Serial No.: 09/771,416

For: UNIVERSAL CLEAT

**PETITION FOR EXERCISE OF THE
COMMISSIONER'S SUPERVISORY AUTHORITY**

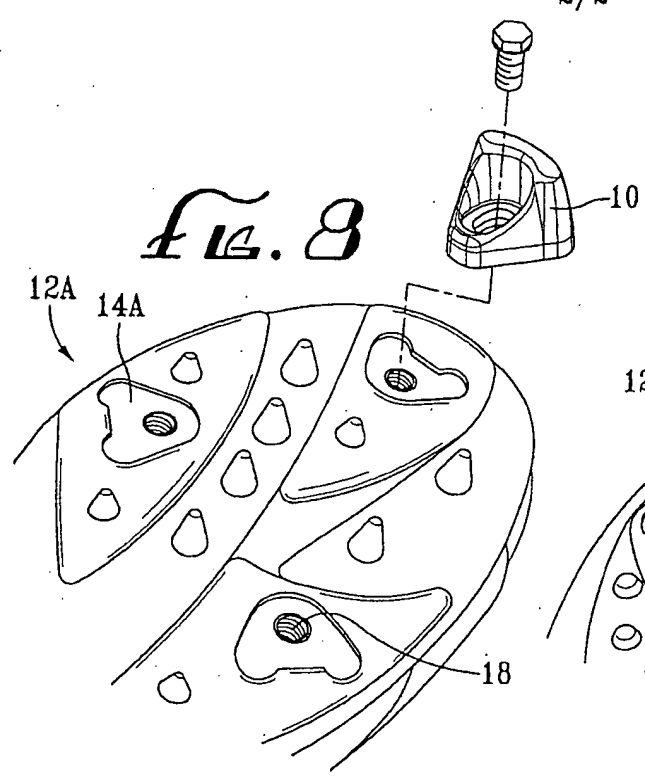
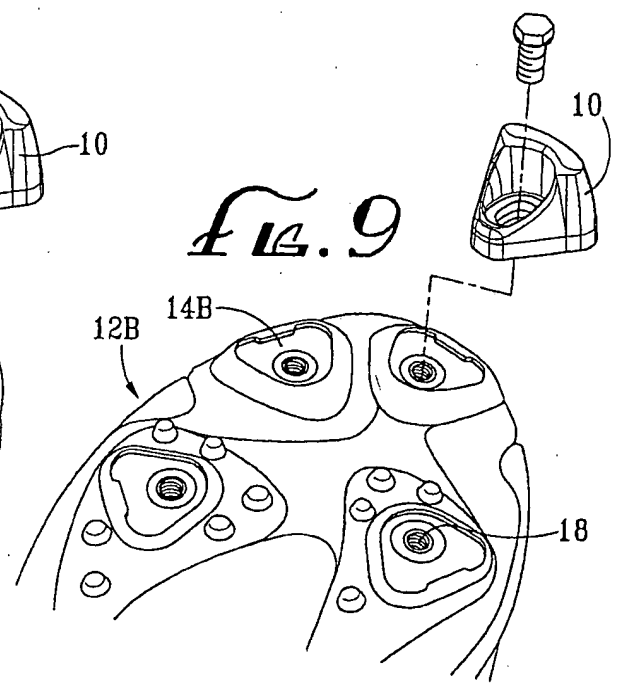
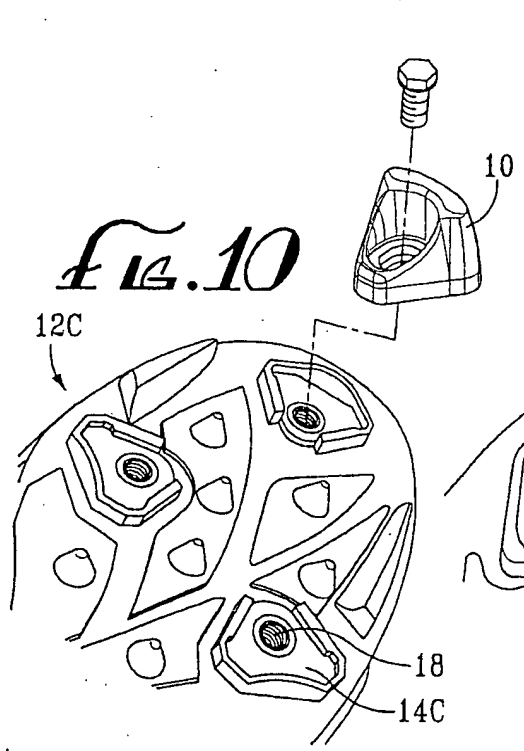
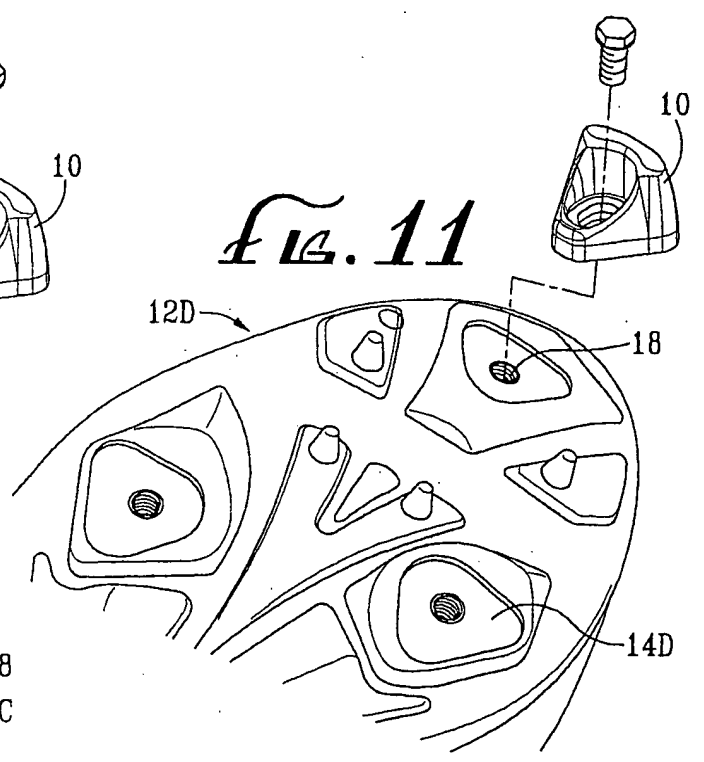
6. The amendment filed May 20, 2003 is objected to under 35 U.S.C. 132 because it introduces new matter into the disclosure. 35 U.S.C. 132 states that no amendment shall introduce new matter into the disclosure of the invention. The added material which is not supported by the original disclosure is as follows: The phrase "has a generally isosceles and /or equilaterally triangular shape recess formed about the receptacle" is not supported by the original disclosure.

With respect to the phrase "with a longest side of said three sides of said base being shorter than the longest side of any of said triangular recesses" Applicant has no support to claim it this way because this is only one possibility and not the only possibility that the Figures depict. Furthermore, since Figures 8-11 do not show the universal cleat completely sitting in the recess and the original specification does not teach the universal cleat completely fitting into the recess, it will not be clear to one skilled in the art that the longest side of said three sides of said base being shorter than the longest side of any of said triangular recesses since the cleat can be partially fitted into the recess and therefore, the longest side of the three sides of said base could be longer than the longest side of any of said triangular recesses.

10. Applicant's arguments filed August 04, 2005 have been fully considered but they are not persuasive. Contrary to applicant's arguments Figures 8-11 do not show the new limitations considered as new matter, see above arguments. Therefore these drawings can not be the basis for addition of descriptive material not shown by these drawings to the original written description.

As principally shown in Figure 8, a first shoe 12a, One of the shoes provided by a first one of the manufacturers, has formed the bottom exterior surface an equilateral three-sided includes a generally triangular recess 14a formed in the sole around about the threaded receptacle 18, sides of the generally triangular recess 14a extending transversely outwardly from the sole shoe bottom exterior surface, with vertices of the generally triangular recess 14a being rounded, two of the sides being straight linear and a third side having defining an inset inboard of the a line which, if drawn, would connect two of the vertices in a the same manner as identically to that of the straight linear sides.

As shown in Figure 9, a A second shoe 12b, provided by a second one of the manufacturers, has a generally equilaterally triangular shaped raised portion extending outwardly respecting the sole, bottom with sides of the triangularly shaped raised portion sloping inwardly relative to the triangularly shaped raised portion with increasing distance from the sole bottom. The vertices of the triangle generally triangular recess 14b are rounded. Outer edges of two Two of the sides of generally triangular recess 14b are straight triangular or linear and a third side defines has an inset inboard of a line which, if drawn, would connect two of the vertices in the same manner as identically to that of the straight linear sides. The triangularly shaped raised portion is positioned around about the threaded receptacle 18 formed in the sole bottom, with the threaded receptacle 18 substantially midway between the center of the triangularly shaped raised portion and a vertex connecting the two straight sides linear edges.

As shown in Figure 10, a third shoe 12c provided furnished by a third one of the manufacturers, has a portion of generally triangular rib configuration extending raised transversely from the sole bottom and surrounding the threaded receptacle 18. adjacently to Generally triangular rib is open, the two ends of generally triangular rib stopping short of where one vertex of the generally triangular rib configuration would be if the two sides of the generally triangular rib leading theretowards were extended to intersect. The two sides of the generally triangular rib configuration are of equal length and are connected by a third side having a continuous arc is swung from the top of the third side in a plane parallel to the third side and perpendicular to the sole. about the receptacle. The two equal length sides of the triangular configuration, if extended to intersect, would be defined by vertices, terminating short of intersection and being connected by straight line edges of the portion of generally triangular configuration, to a third side of the triangular configuration. The generally triangular rib includes an upstanding lips extending inwardly toward the center of the triangle and parallel with the sole from the tops of each of the two equal length sides, bordering the triangular portion remote from the receptacle with edges of the lips bounding bordering the two equal length sides of the triangular portion, and stopping short of intersection vertices of said triangular rib.

As shown in Figure 11, a fourth shoe 12d, provided by a fourth one of the manufacturers, has a generally triangular recess 14d formed about threaded receptacle 18. Vertices of generally triangular recess 14d are rounded and sides of the recess are straight with two equal length sides being substantially the length of the straight sides of generally triangular recess 14b of second shoes 12b. The third side is longer than the equal length sides. The third side is straight.

Furthermore, Applicant respectfully submits that the cited phrase is supported by the original disclosure. As stated *supra*, the cited phrase was inherently contained in the original application as shown in at least Figures 8-11. In fact, the Applicant respectfully submits that Examiner had done exactly that which the Examiner objects to in the current Office Action. At pages 7-8, the Examiner rejects claims 1, 3-4, 6-7 and 9 by asserting that U.S. Patent 5,943,795 ("Ueda") teaches "that it is desirable to have the mounting hole oblong shape" by only referring to Figure 7 and no other written language. Office Action, page 7, lines 17-19. See also Office Action, page 8, lines 3-4 (asserting the ratio of the length of the mounting hole to the width of the mounting hole "appears" to be 8:7 to about 10:7). If the Examiner asserts Ueda teaches a limitation of the Applicant's claims by only referring to a drawing, then Examiner must agree that the drawings are part of the disclosure. Therefore, if the Examiner agrees that the drawings are part of the disclosure, then merely reciting what is already disclosed in the drawings do not constitute new matter.
